PLANNING AND ZONING JULY 14, 2016 @ 7:00 P.M.

1. CONSIDERATION AND/OR ANY APPROPRIATE ACTION ON PARKER STORAGE FACILITY DEVELOPMENT PLAT AND PRELIMINARY ENGINEERING PLANS.

Re: Parker Storage Facility
Development Plat & Preliminary Engineering Plans

To: Jeff Flanigan
From: Joe R. Carter, P.E., C.F.M. (#64008) & (#1698-09N)
Date: June 23, 2016
Subject: Storage Facility Flood Study – Fourth Review

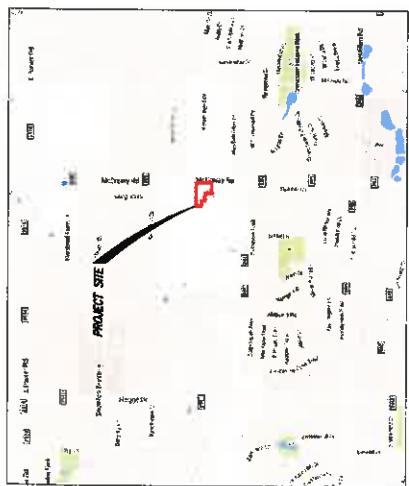
4. (Previous comment 5) Normally no rise is allowed in the 100-year water surface elevation since no adverse impact on properties upstream or downstream is allowed.

- There is insufficient information provided with this submittal to determine what if any water surface elevation increases may result from this project.

- *This is not quite an accurate statement. What was said was that any increase in the base flood elevation must be approved by all impacted property owners. No rise exceeding 1-foot is permitted and we do not have a post-project model revising the existing model to show the proposed fill from this development to determine the base flood elevation increases from this development.*

- ◆ *Please address the comments regarding the "n" values used in the existing and proposed models as these may impact the existing and proposed water surface elevations.*

- The response letter includes a statement from the January 13 meeting that any rises in water surface elevation may be acceptable with affected owner permission.

- The response states that the site has been redesigned to remove all buildings from the floodplain and provide 1-foot of freeboard and that there is no longer a rise in the base flood (100-year) elevations due to revised paving and lower Manning's "n" value. The response also states a WSEL Table was added as an attachment.
